**ZONING AMENDMENT
& SUBDIVISION STAFF REPORT**

Date: October 20, 2016

Michigan Bay Subdivision

1201 & 1203 Michigan Avenue
(Southeast corner of Michigan Avenue and Bay Avenue)

DETAIL SITE PLAN

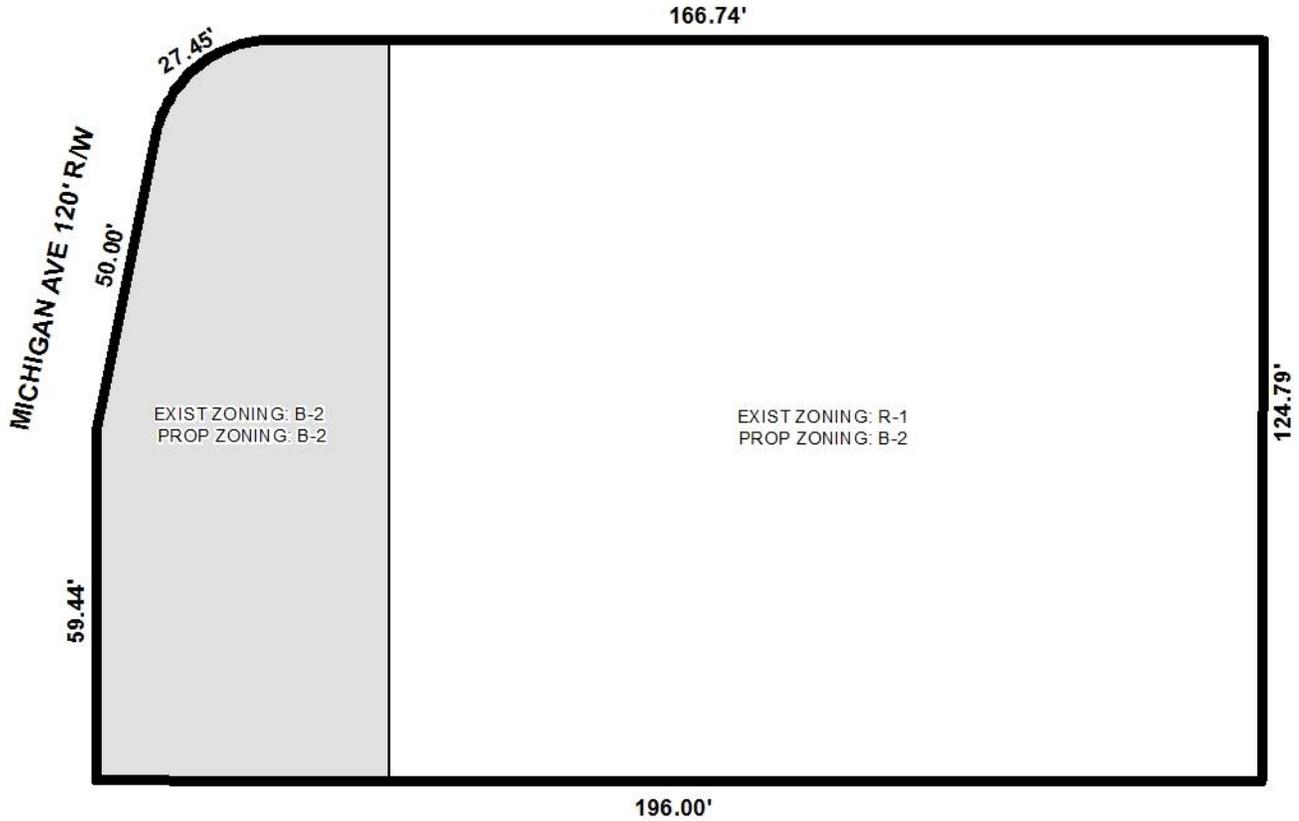
The site plan provided with the zoning request depicts two proposed curb-cuts, a one-way in only from Michigan Avenue, and a two-way curb-cut to Bay Avenue. Bay Avenue is primarily a residential street, thus as proposed, traffic from the proposed commercial development would only be able to exit the site onto Bay Avenue. The Planning Commission approved one curb-cut to Michigan Avenue and one curb-cut to Bay Avenue with the 2013 application, thus such may be appropriate with the request at hand. The size, design and location of any curb-cuts should be approved by Traffic Engineering and comply with AASHTO standards. Any of the existing curb-cuts that will not be used should be removed during the redevelopment process.

It should be noted that while the review and potential approval for a rezoning request is not site plan specific, the site plan required as part of the zoning application is still reviewed for general compliance. As proposed, the site plan does not appear to accommodate the required 10-foot wide protection buffer required by Section 64-4.D.1. of the Zoning Ordinance. The buffer would be required along the South and East property lines, where the site abuts residentially-zoned property. Accommodating the buffer will require the relocation of the proposed building and the proposed dumpster enclosure. The applicant should also be aware that mechanical equipment associated with the development cannot be within the protection buffer.

The site plan otherwise depicts the 6,000 square foot building, 30 parking spaces, a 6-foot high wooden privacy fence along the East and South property lines, trees, landscaping and sidewalks.

Regarding tree and landscaping compliance, the site will have sufficient total and front landscape areas based upon the submitted plan. It appears, however, that the site plan is three trees short of compliance: 10 overstory frontage trees, 5 overstory perimeter trees, and 7 understory perimeter/parking trees are required, for a total of 22 trees. Any site plan submitted for land disturbance should be revised to depict full tree and landscaping compliance.

The proposed 6-foot privacy fence should be reduced in height to 3 feet where it is within the setbacks along Michigan Avenue and Bay Avenue.

As the parking area will contain more than 25 parking spaces, a photometric plan will be required at the time of submittal for land disturbance permits.

- 1) Completion of the Subdivision process;
- 2) Provision of a protection buffer strip, in compliance with Section 64-4.D.1. of the Zoning Ordinance;
- 3) Provision of a 6-foot high wooden privacy fence where the site abuts residentially-zoned property, except within the street setback area, where the fence height is limited to 3-feet; and
- 4) Full compliance with all other municipal codes and ordinances.
